Verification Report

McAlear & Rushe

101 Charles Street

AREA SURVEYED: Pile Cap on A10 and B6 and Cores D7 and D5

VERIFICATION ITEM TWO

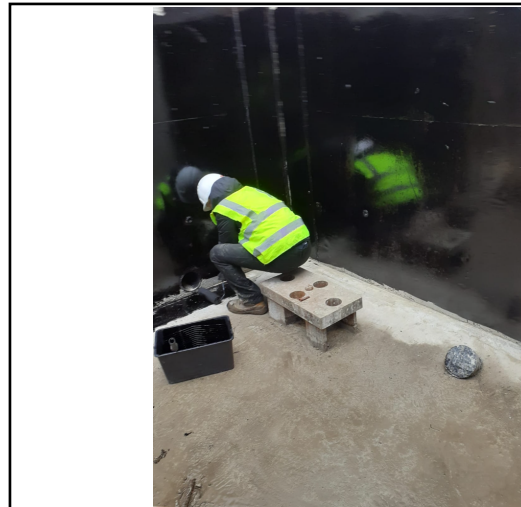
LOCATION/GRID LINE: Core D7 and D5

NOTES: Core D5 is now complete. Core D7 is on going and

requires water removing from the base to allow a good seal with the GR SAM.

Further prep works required on D7 as done with D5
